TECHNICAL BULLETIN

NO. 214-78-18

SUBJECT: REINFORCEMENT/REPAIR OF TAIL BOOM
P/N 214-030-003-7

HELICOPTERS AFFECTED: All Model 214B/R1 helicopters

TAIL BOOM REINFORCEMENT
FIGURE 1

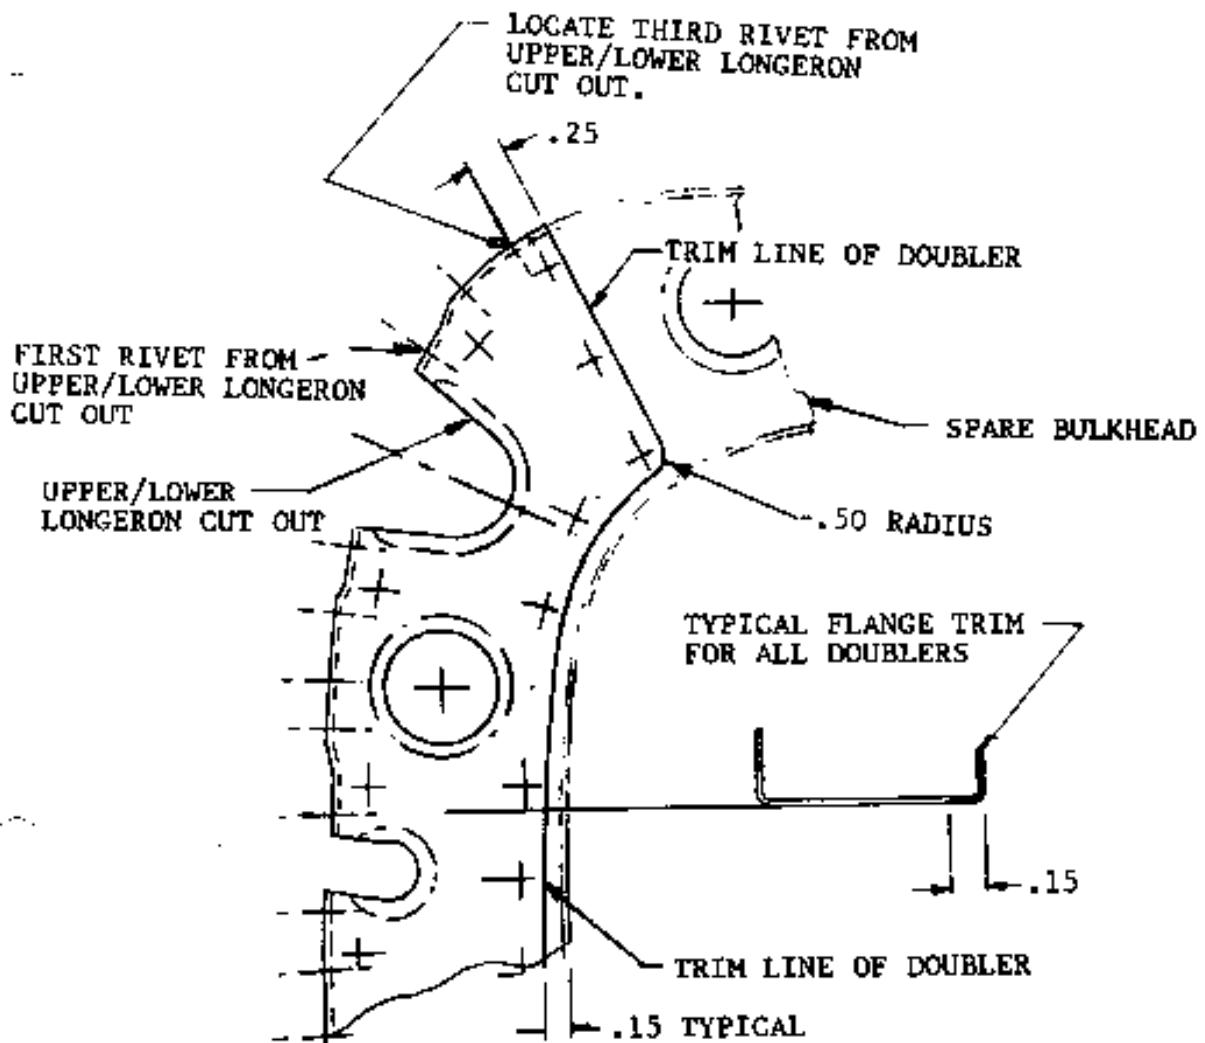
1. Refer to figure 1. Gain access to the interior of the tail boom by removing all the lower access panels.
2. Inspect each bulkhead in the area of the longerons and "J" stringer for cracks. If crack or cracks are found stop drill with a No. 40 drill.

FIGURE 2

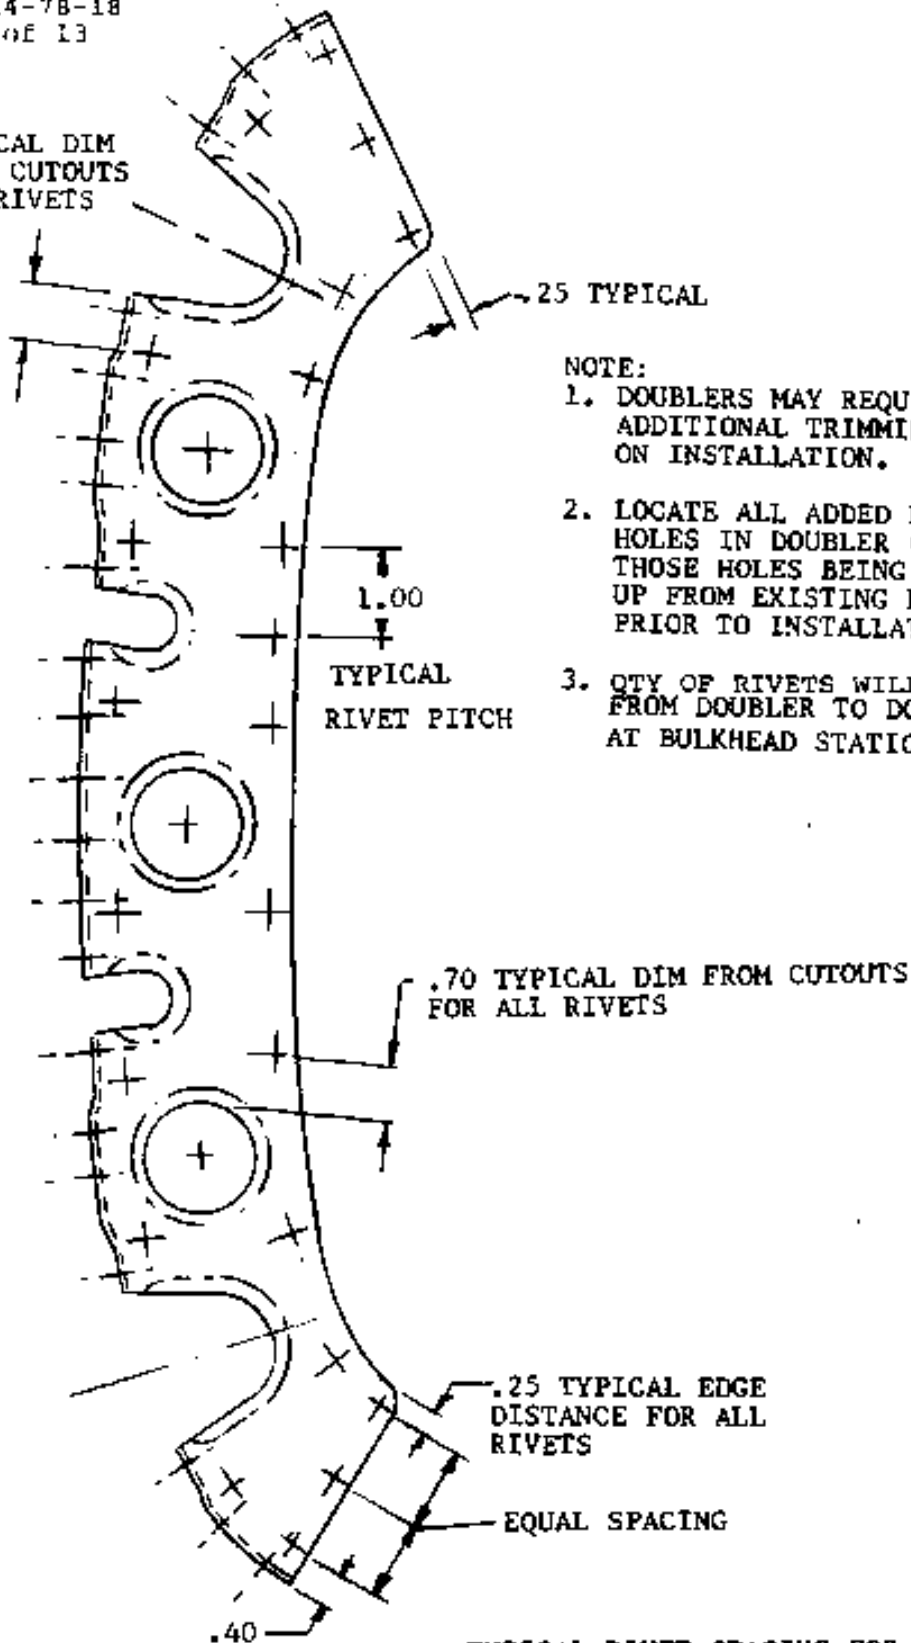
3. Refer to figure 2 and 3. Cut doublers from each spar bulkhead. Locate and drill No. 40 pilot holes, all added holes. Mark each doubler set with bulkhead part number.

1. TYPICAL TRIM LINE FOR BOTH UPPER AND LOWER ENDS AND LEFT AND RIGHT SIDE. SEE FIGURE 3 FOR RIVET SPACING
2. BREAK ALL SHARP EDGES

FIGURE 4

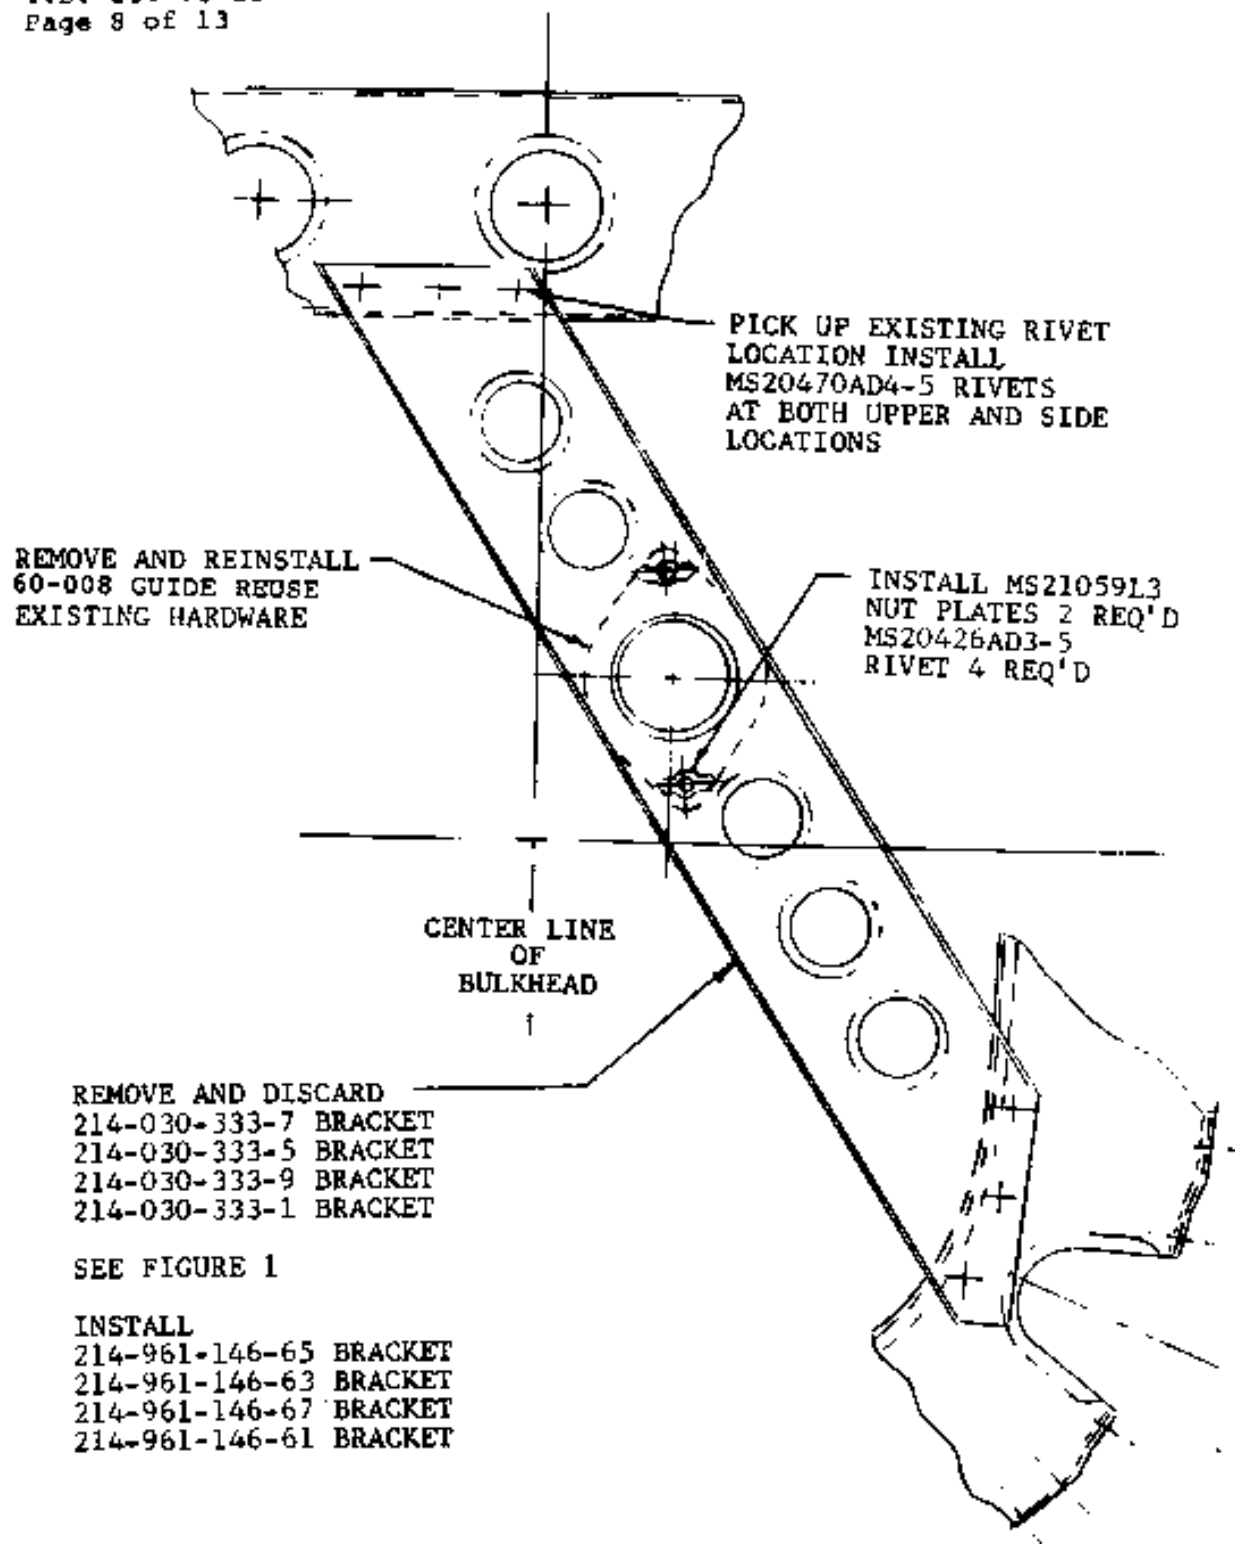
6. Refer to figure 4. The following instructions are typical for all bulkhead to be repaired. Remove all rivets that fall in the area to be covered by the doubler. Fit the doubler to nest into the bulkhead flange (doublers may require additional trimming to suit each condition). Pick up all holes in the doublers from the bulkheads and all holes in the bulkhead from the doublers. De-burr all holes.

FIGURE 5

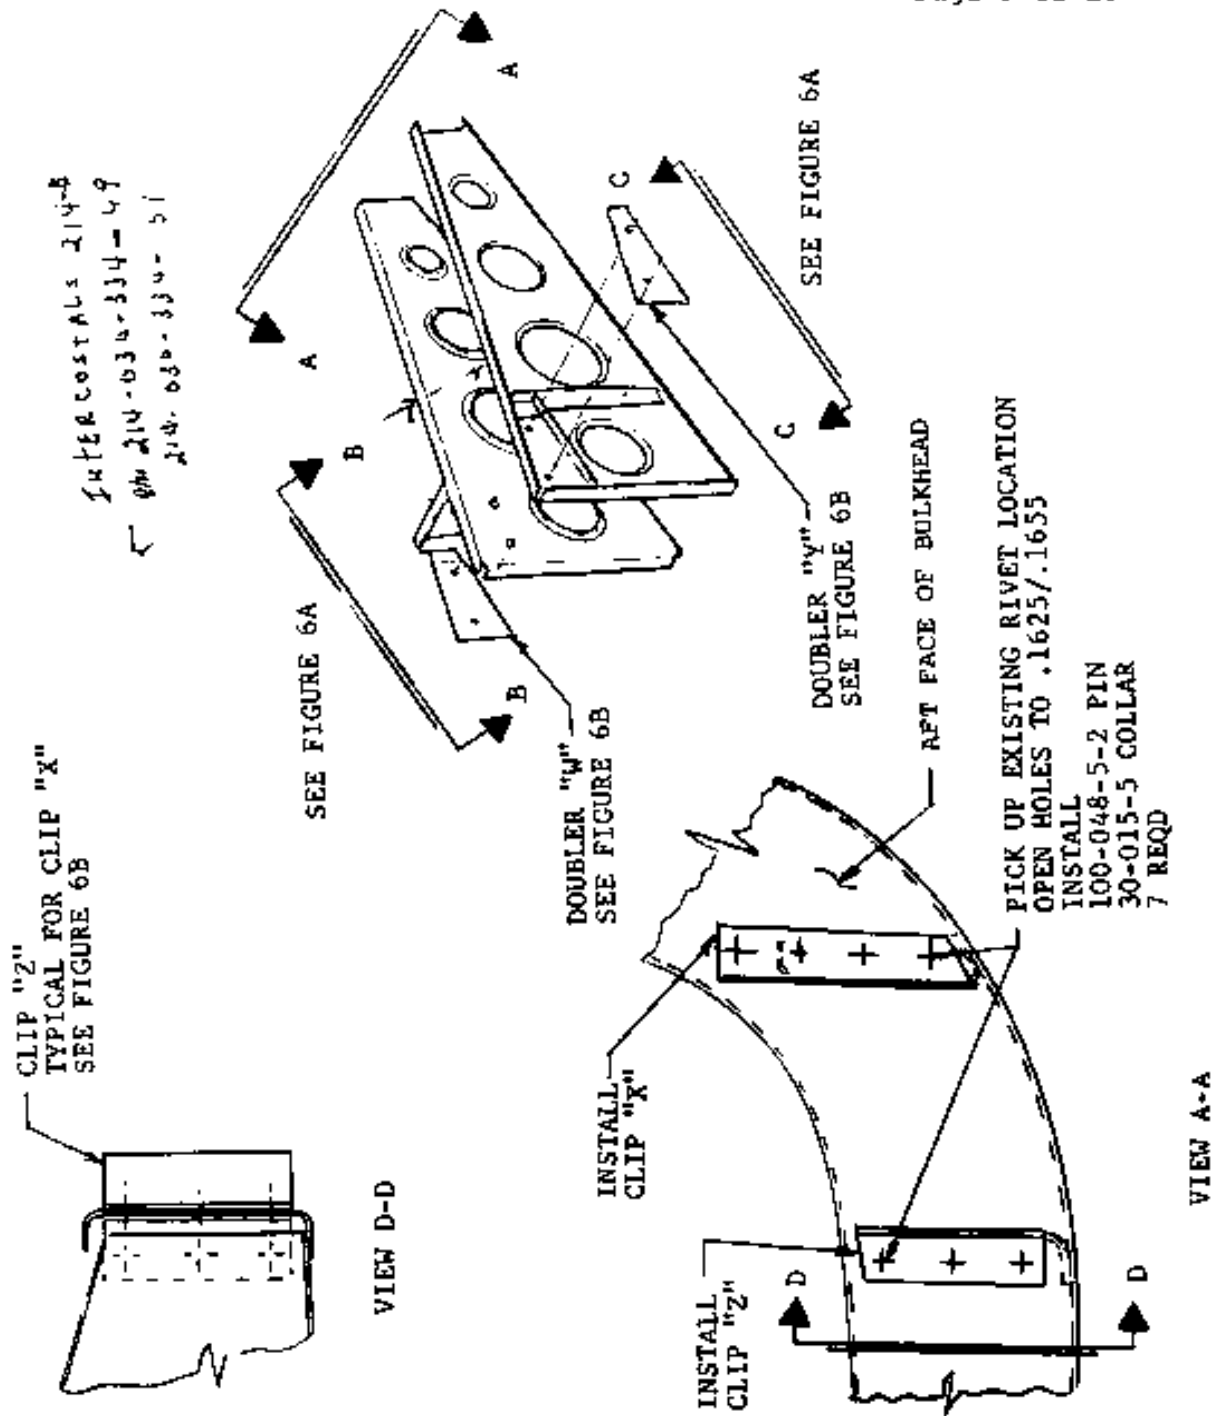
4. Disconnect and remove from the guide brackets all control tubes that will interfere with the installation of doublers and new guide brackets.
5. Refer to figure 5. Remove guide brackets from bulkheads. Remove the guides and retain the hardware. Install the nutplates to the new brackets, reinstall the guides with retained hardware.

7. Refer to figure 5. Install new guide brackets.
8. Refer to figure 6B. Fabricate doublers "W" and "Y" and clips "X" and "Z". Alodine and prime with epoxy primer.

FIGURE 6

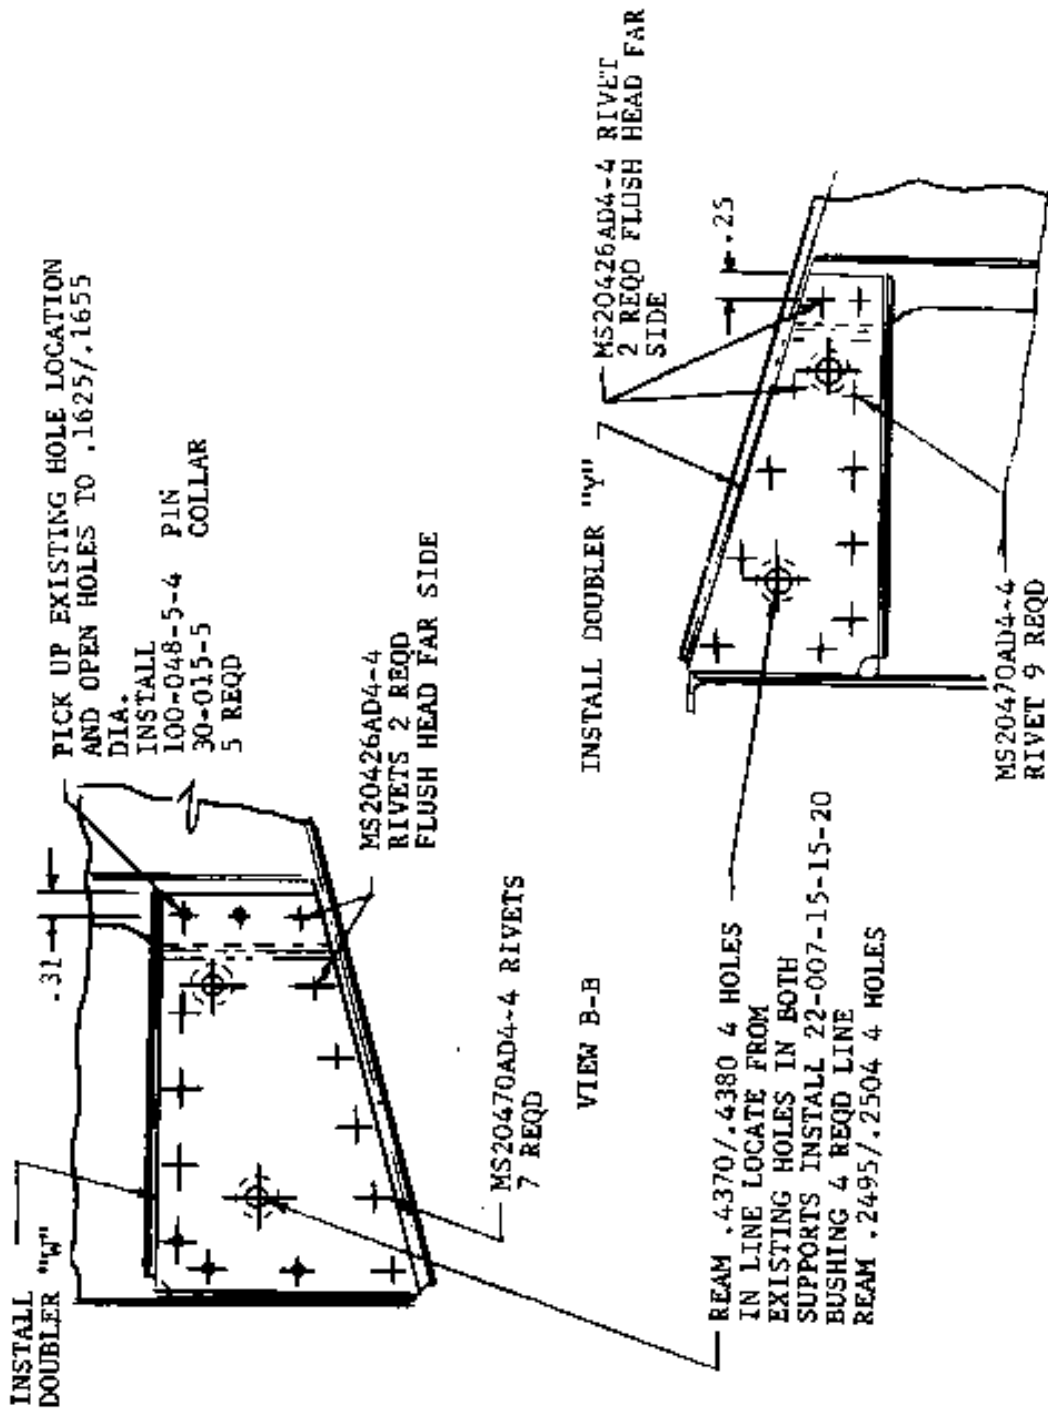
9. Refer to figures 6 and 6A. Remove the elevator and anti-torque, control bellcranks from support assembly. Remove rivets that fall in the area to receive the doublers. Remove (4) bushings two each side. Temporarily attach doublers and pick up existing holes, de-burr all holes. Locate and install doublers, ream hole and press the bushing in.

10. Refer to figure 6. Remove the rivets attaching the aft clip to the bulkhead. Temporarily attach the clips, pick up existing holes, de-burr all holes. Install clip with Hi-Lok pins and collars.

ANGLE DETAIL AND INSTALLATION
FIGURE 7

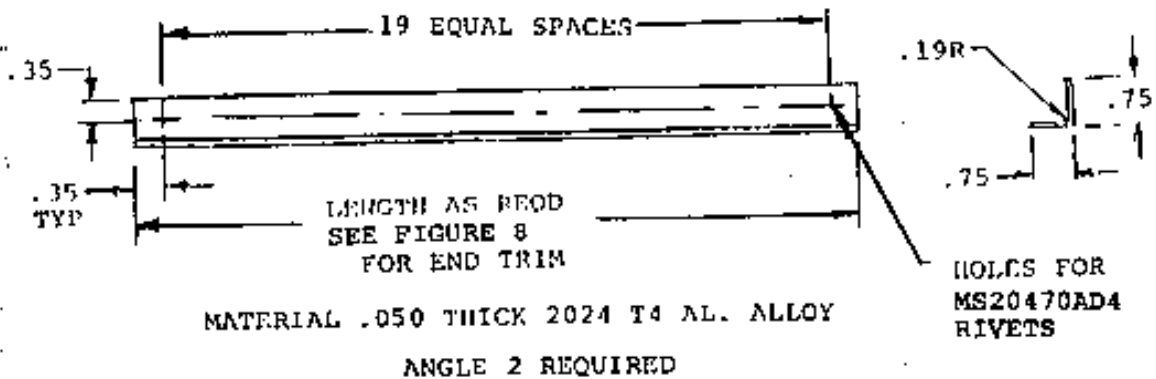
12. Refer to figures 7 and 8. Fabricate two angles and four clips. Locate the angles and clips. Drill all holes in the skin and bulkhead from the angles and clips. Remove angles and clips, de-burr all holes. Reinstall angles and clip with rivets as called out. Coat angles and clips with epoxy primer. Reinstall all removed panels.
